UNITED STATES PATENT AND TRADEMARK OFFICE

10/773,016

Office Action Summary	Application No.	Applicant(s)	
	10/773,016	ANDERSON, R. DAVID	
	Examiner	Art Unit	
	Gene L. Bankhead	3744

DETAILED ACTION

Figure 5 (Longardner)

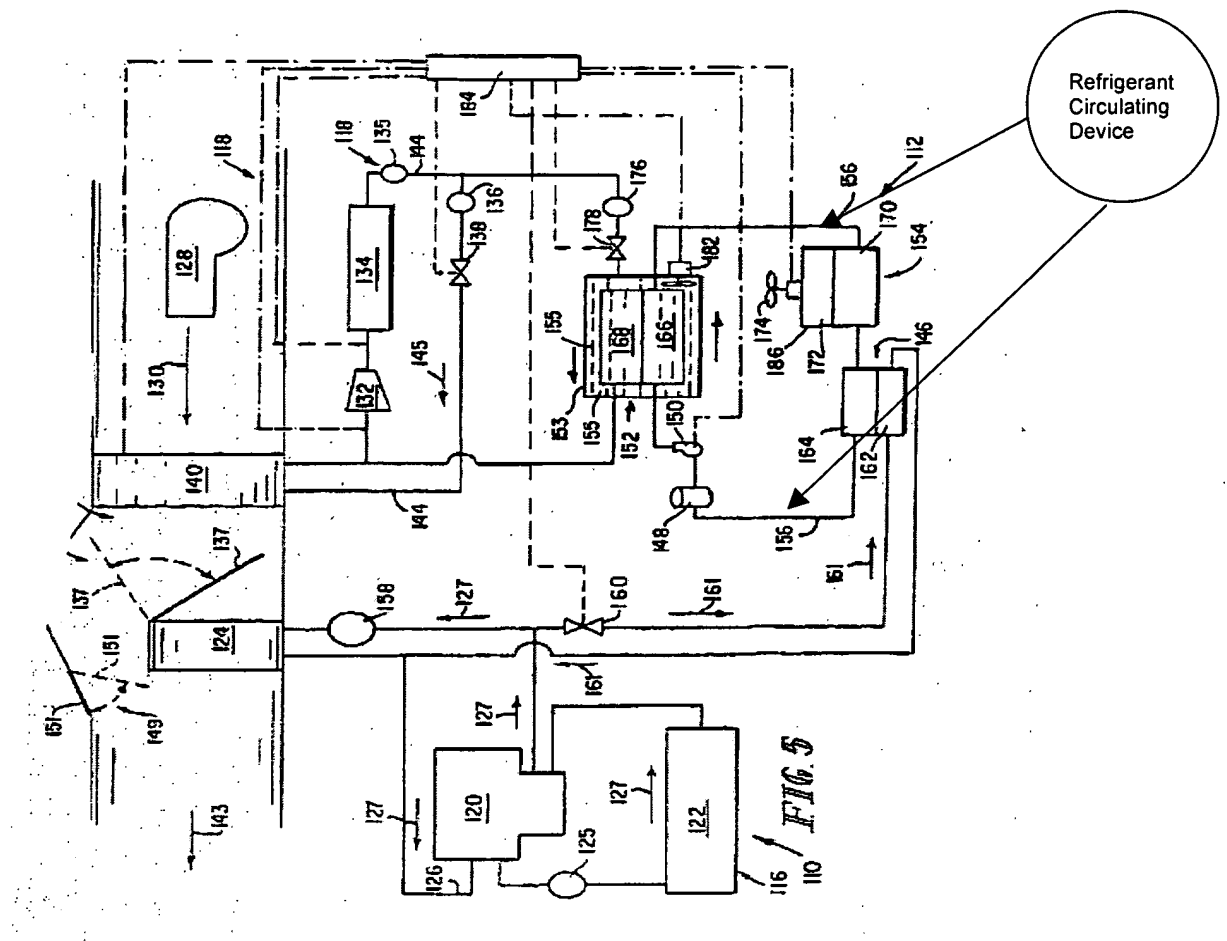
Claims 1,2,8-10,15-19, 24 and 25 are rejected under 35 U.S.C. 102(b) as being anticipated by Longardner (US 5553662). Longardner discloses a thermal energy storage system connected to an air conditioning system. The system comprises a compressor 132 capable of compressing a refrigerant, a condenser 134 connected to the compressor (see Figure 5), an expansion valve 136 and an evaporator unit 140 in heat exchange relationship with an air stream (column 11 lines 10-23). Longardner further discloses a thermal energy storage unit 112 with a tank 152 having a storage medium and an associated heat exchanger 146 between the condenser and evaporator (column 12 lines 29-37). Longardner further teaches a refrigerant circulating device 156, capable of circulating refrigerant through the heat exchanger, between the tank, condenser and evaporator (column 12 lines 29-37, 62-68 and column 13 lines 1-10 and Figure 5). The refrigerant circulating device includes a prime mover 150 and an auxiliary liquid (column 12 lines 40-44 and Figure 5), with the force of the prime mover exerted on the auxiliary liquid being indirectly transferred to the refrigerant (column 12 lines 45-68 and column 13 lines 1-10).

In regards to claim 9, Longardner teaches all limitations of claim 1. He further discloses a second temporary thermal energy storage tank 154, as recited in claim 9 line 30. Longardner discloses a valve system, 138 and 178, capable of controlling the flow of refrigerant through the system. The valve system is capable of operating to provide the three distinct time periods, as disclosed in claim 9:

Figure 6 (Clark Jr.)

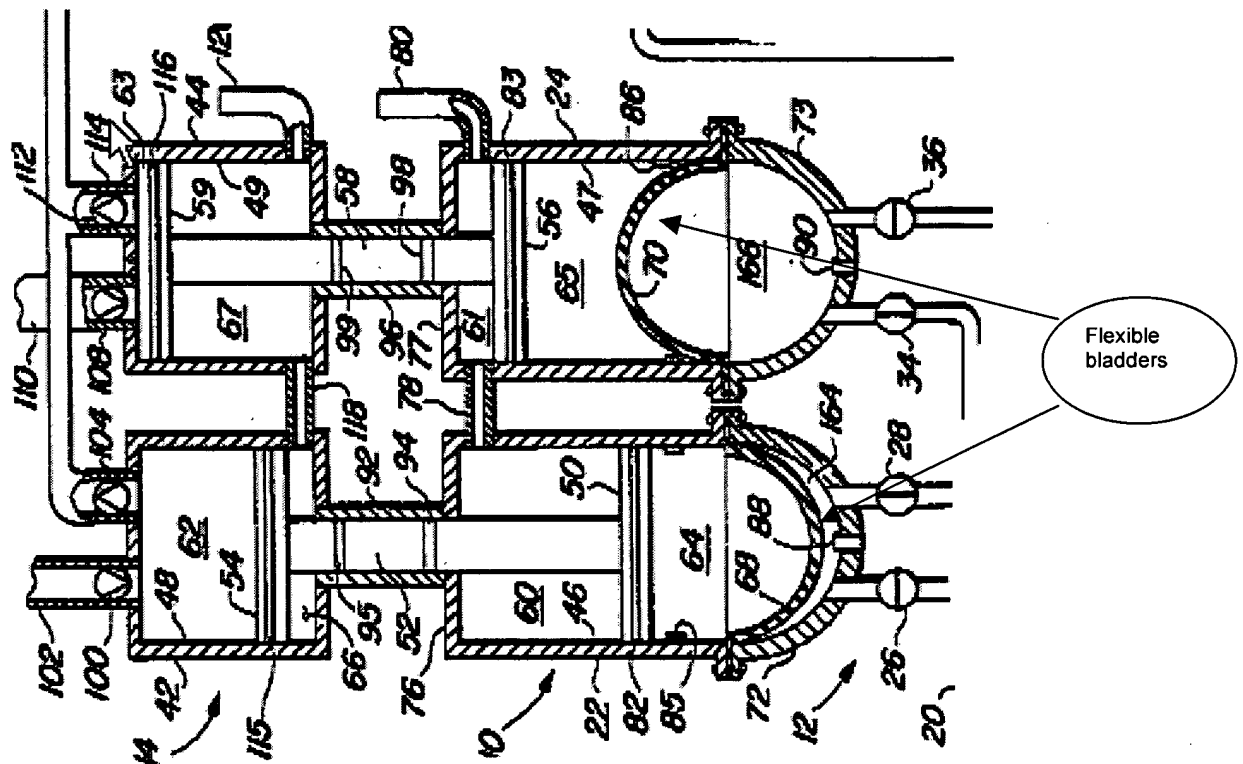
Regarding claims 6,13 and 22 Clark Jr. further teaches flexible bladders 68 and 70 located within each of the fluid cylinders, see Figure 6.
